Attachment 12 – Air Quality Response, SLR

Blackwattle Bay
Response to Submissions

Blackwattle Bay Precinct - Air Quality Revised Precinct Plan and Responses to Submissions

Figure 1 Comparison of Exhibited and RtS Precinct Plans

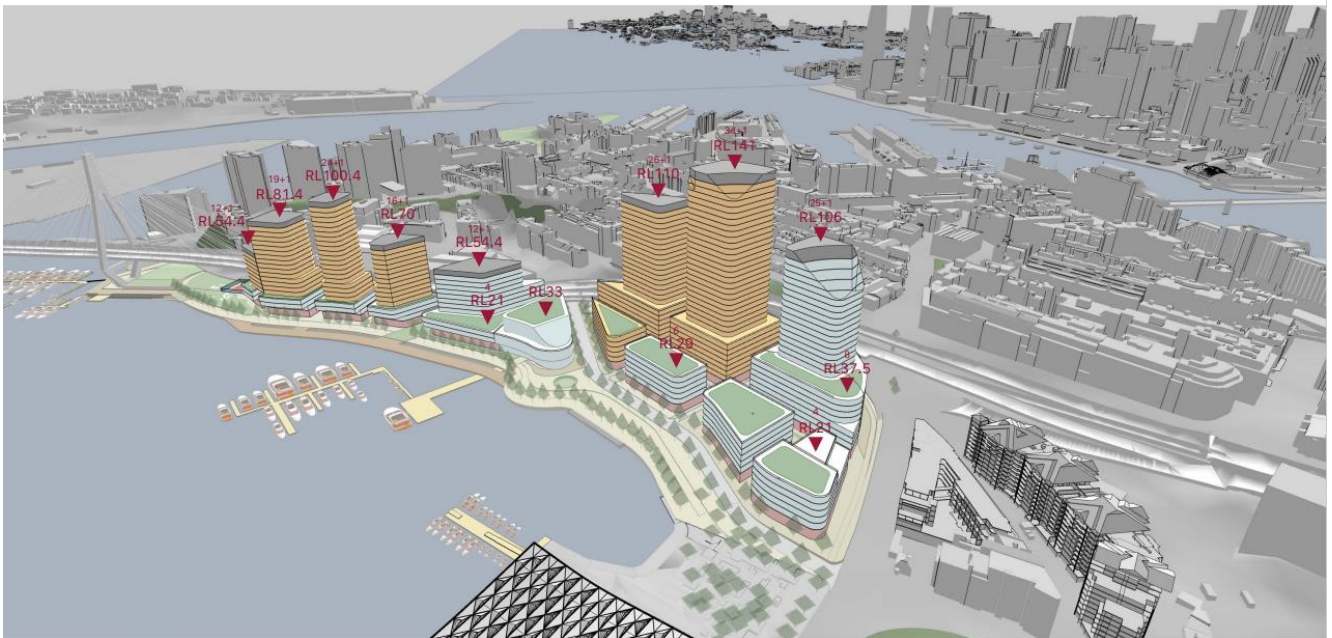
- Proposed building footprints have been moved out of the City of Sydney land parcel adjacent to Bank Street near the intersection with Pyrmont Bridge Road. This locates some of them slightly farther away from the Western Distributor. There is no change to the distance from Pyrmont Bridge Road.
- Removal of Building 07 and reduction from 8 storeys to 6 storeys for Building 2B, Building 06, Building 5A and Building 5B. Building PL01-1 has also reduced in height to RL54.4m from RL65m.
- Further reductions to Building 5B and Building 03 podium to improve amenity of adjacent residential.
- Increase in height of Building PL02 tower from RL91.5 to RL100.4m
- Adjusted building footprints for Buildings 05A, 05B and 06, and repositioning and reduction of tower envelope for Building 02, now Building 2A.
- An increase in tower separations for Private Landowner sites to minimum 24 m above 8 storeys.

Overall, the private landowner buildings have the same distance from the Western Distributor in the amended RtS Precinct Plan as the exhibited Precinct Plan. For the buildings on the existing Sydney Fish Market site, there is no change in distance from the Western Distributor for Building 2A, a slight increase of approximately 2 m in the setback from the Western Distributor for Building 03, and a slightly larger increase in the setback for Building 04 (approximately 5-7m). The Celestino (PL02) massing is also slightly narrower than what was illustrated in the exhibited Precinct Plan, giving more space between their tower and the adjacent towers, which should improve dispersion of air pollutants in this area. However, the gap between Building 2A and Building 03 has narrowed.

There have also been changes in the proposed use on some floors of the buildings as illustrated by the changes in the orange (residential) and grey (commercial) colouring in **Figure 1**.

While the slight increases in setbacks from the Western Distributor and tower separations for Private Landowner sites should result in the predicted concentrations reducing in some areas, significant changes model predictions are not likely. However, as residential use is now proposed at lower levels in many of the buildings, it is recommended that the modelling be revised and updated during the detailed design stage to assess the impact on air quality at the proposed residential and commercial areas. The HHRA may also need to be updated based on the revised model outputs. If the modelling predicts significant exceedances at proposed residential locations, additional mitigation measures could be adopted. These can include:

- Reducing the number of apartments facing the Western Distributor by designing building cores to the east; or
- Provision of mechanical ventilation for apartments facing the Western Distributor with fixed glazing to the east and operable windows to non-impacted facades.
